Attachment 2 TO AEP:NRC:1077A  
PROPOSED TECHNICAL SPECIFICATION CHANGES

Attachment 3 TO AEP:NRC:1077A

DONALD C. COOK NUCLEAR PLANT UNIT 2 CYCLE 7  
SAMPLE CORE OPERATING LIMITS REPORT

FIGURE 1

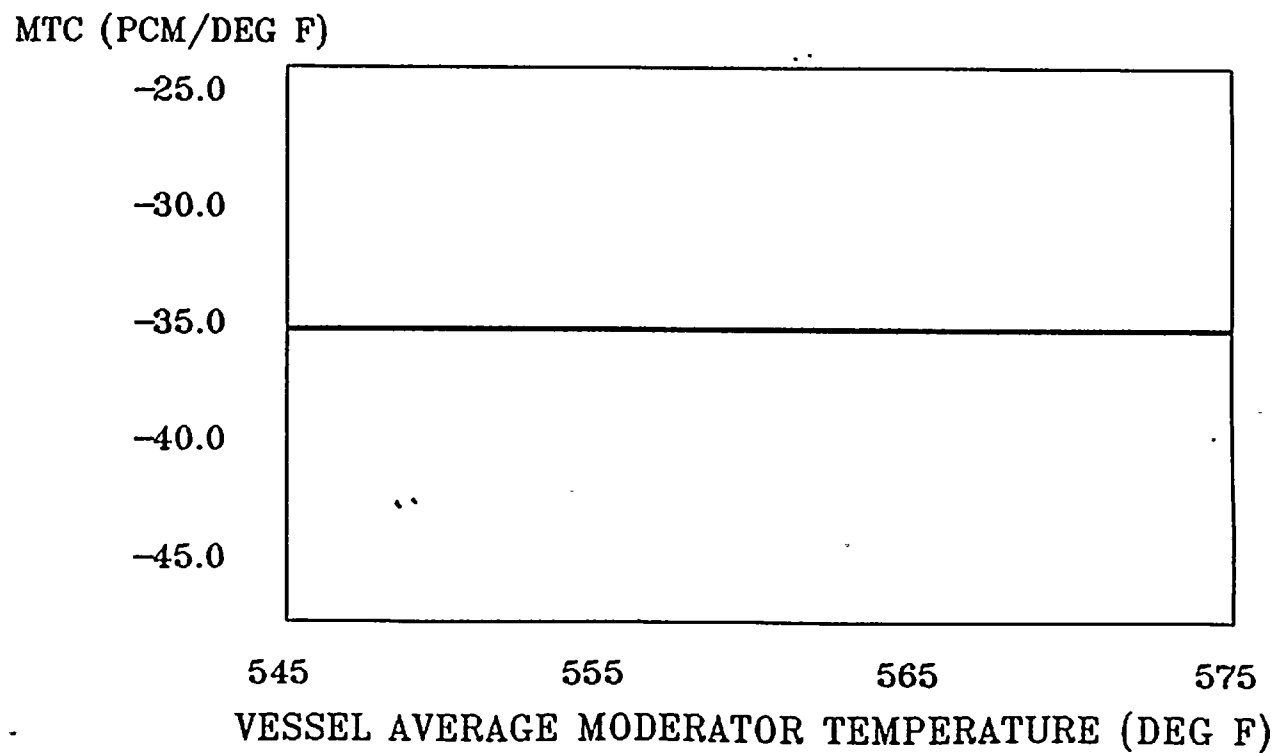
2.1.1 The Moderator Temperature Coefficient EOL Limit is:

The EOL/ARO/RTP-MTC shall be less negative than the value given in Figure 1.

Figure 2

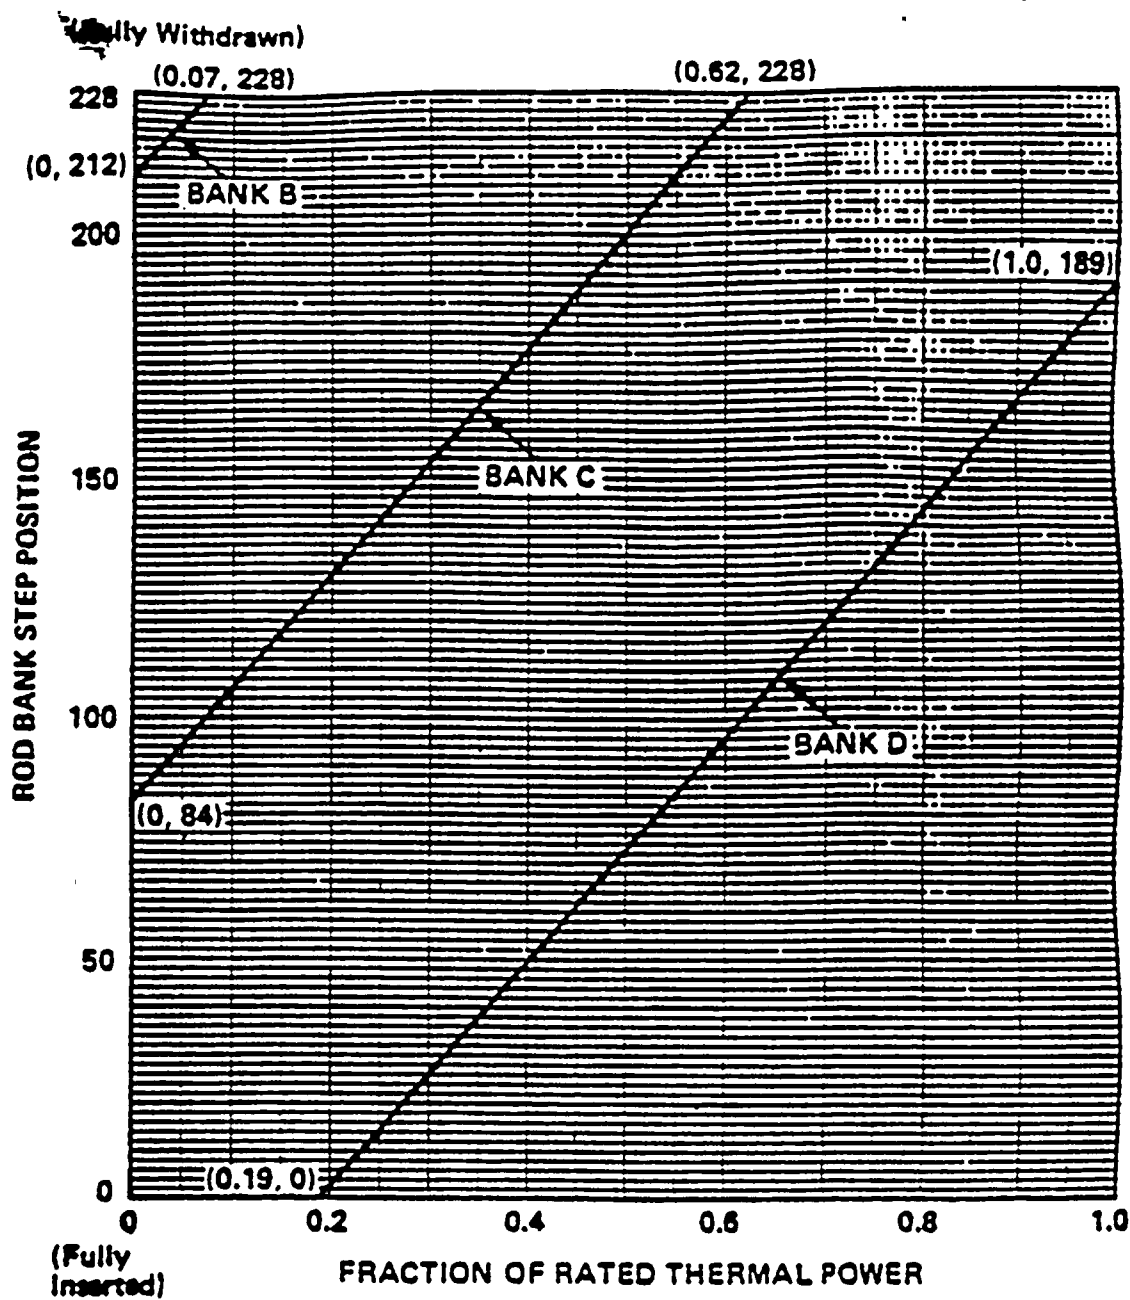
2.4.1 The control banks shall be limited in physical insertion as shown in Figure 2.

2.4.2 Successive Control Banks shall overlap by 100 steps. The sequence for Control Bank withdrawal shall be Control Bank A, Control Bank B, Control Bank C, and Control Bank D.

Figure 3

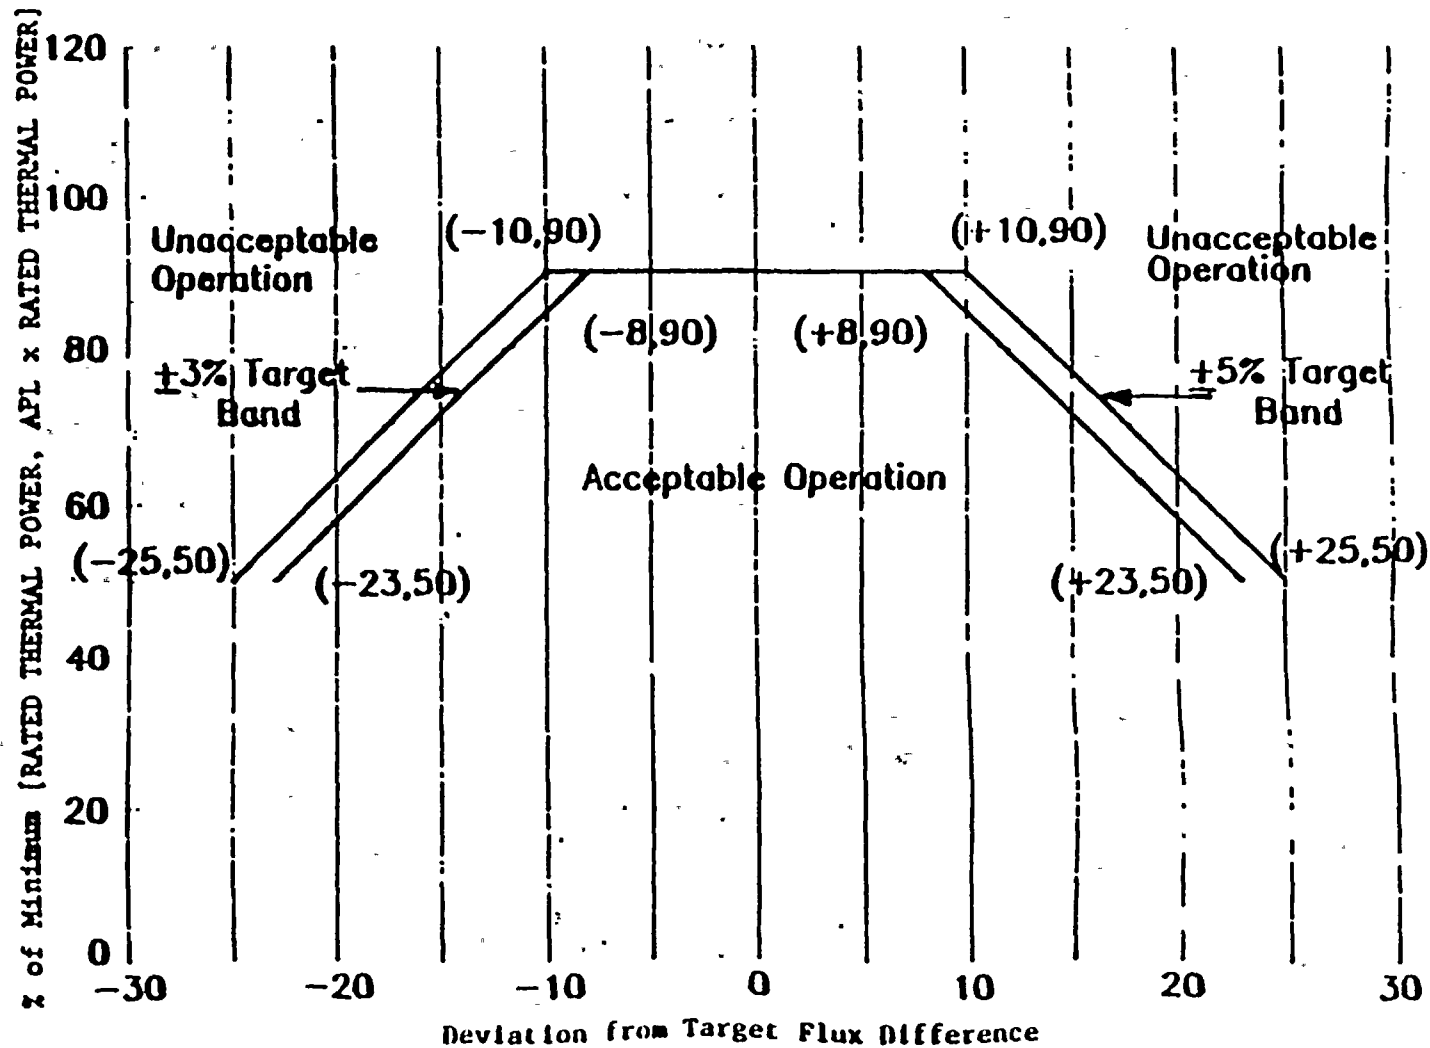
2.5.1 The Allowable Operation Limits are provided in Figure 3.

FIGURE 4  
K(Z) - NORMALIZED FQ(Z) AS A FUNCTION OF CORE HEIGHT  
WESTINGHOUSE FUEL

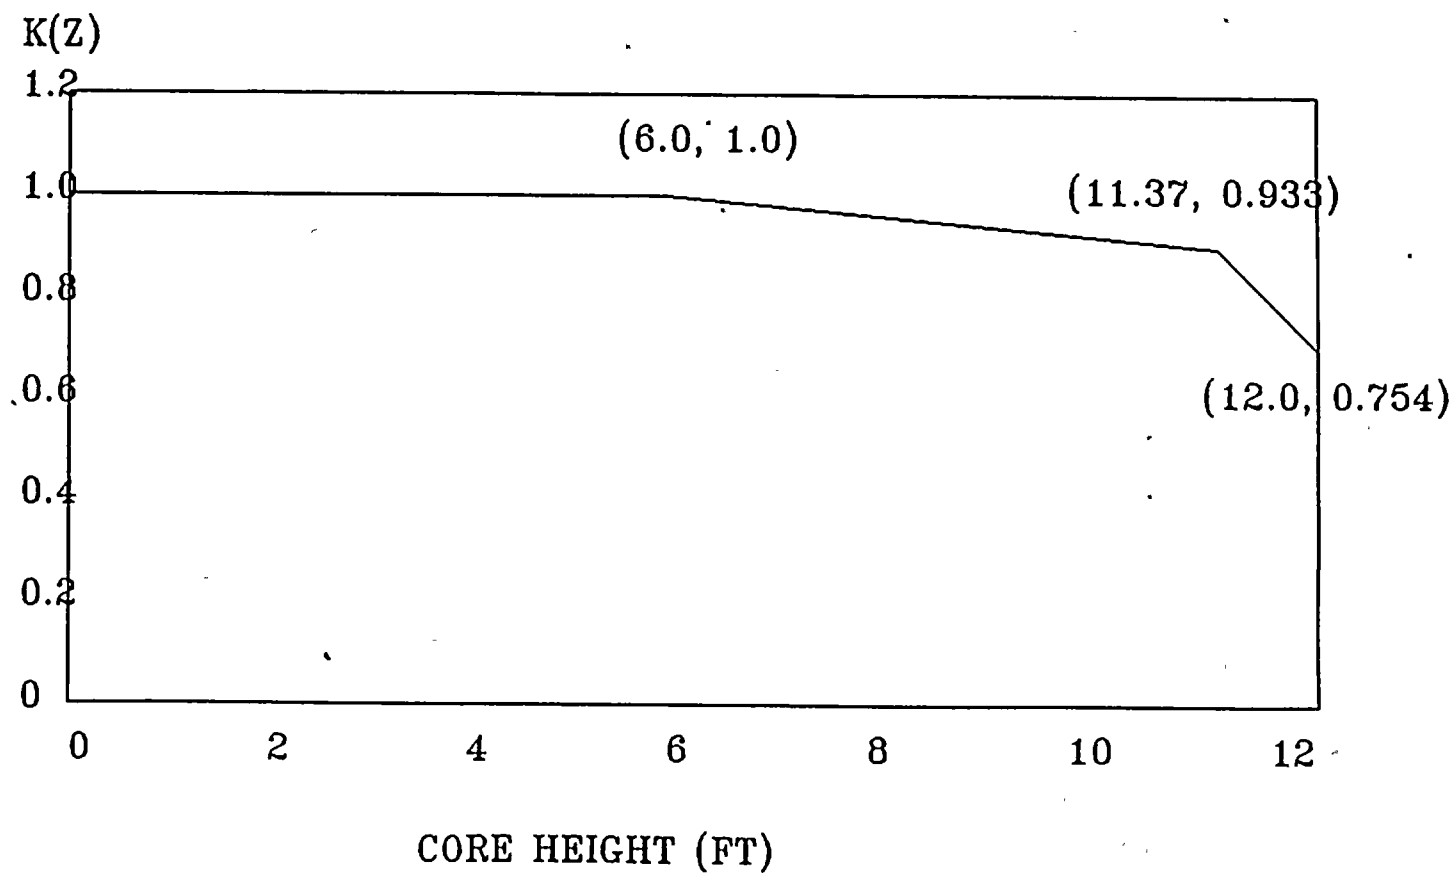
2.5.2  $K(Z)$  is provided in Figures 4 and 5  
for the respective fuel type

FIGURE 6  
V(Z) AS A FUNCTION OF CORE HEIGHT

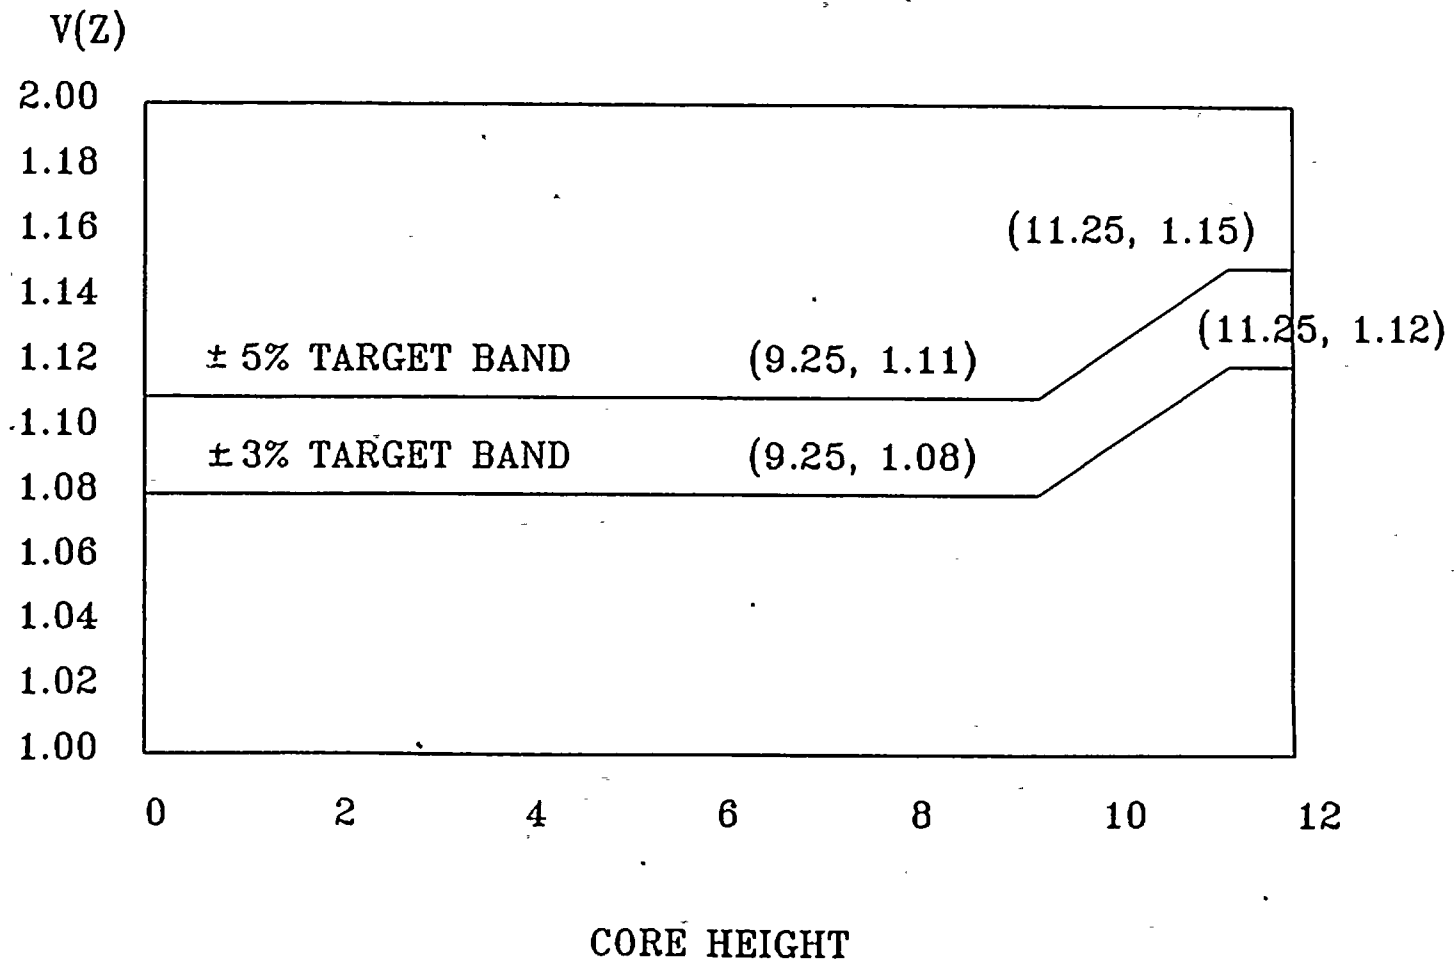
2.5.3  $V(Z)$  is provided in Figure 6
